Virgil C. Summer Nuclear Station (VCSNS) Units 2 and 3
Combined License Nos. NPF-93 and NPF-94
Docket Nos. 52-027 & 52-028

Subject: Request for License Amendment: Additional Electrical Penetration
Assemblies

**License Amendment Request:
Additional Containment Electrical Penetration
Assemblies**

**Figure 6.2.5-1
Containment Leak Rate Test System
Piping and Instrumentation Diagram**

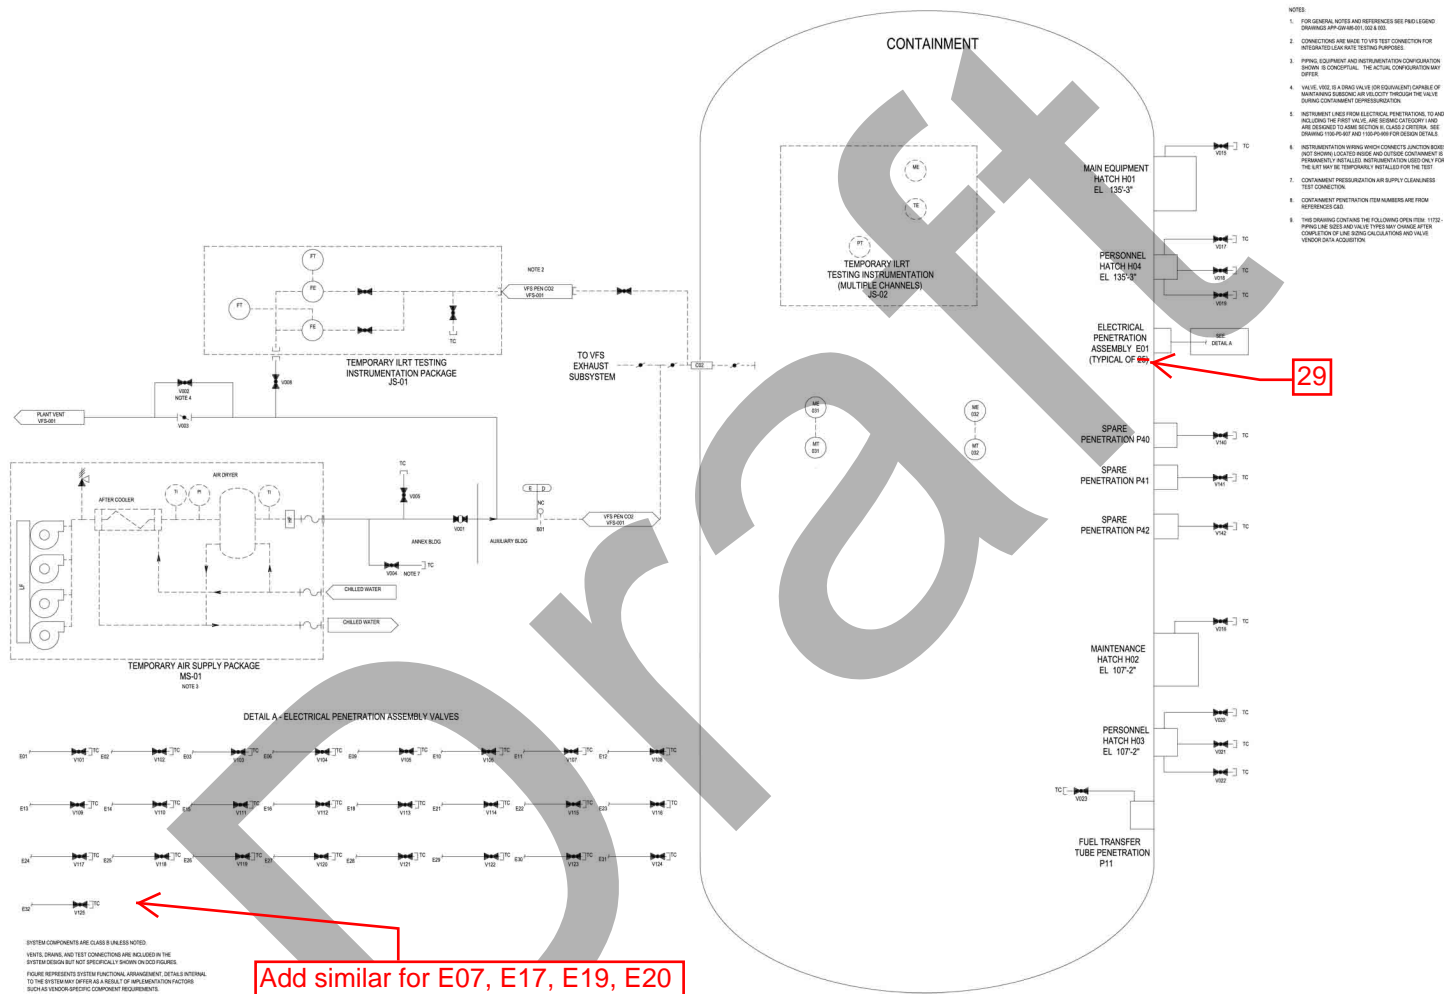
- Addition of Electrical Penetration Test Isolation Valve VUS-PL-V128
 - Addition of Electrical Penetration Test Isolation Valve VUS-PL-V129
- Figure 6.2.5-1:

- Change descriptive text for Electrical Penetration Assembly E01 from "(Typical of 25)" to "(Typical of 29)"
 - Change 'Detail A – Electrical Penetration Assembly Valves' by adding details E07 (with test isolation valve V126), E17 (with V127), E19 (with V128), and E20 (with V129) adjacent to existing detail E32 (with V125) and with a similar configuration.
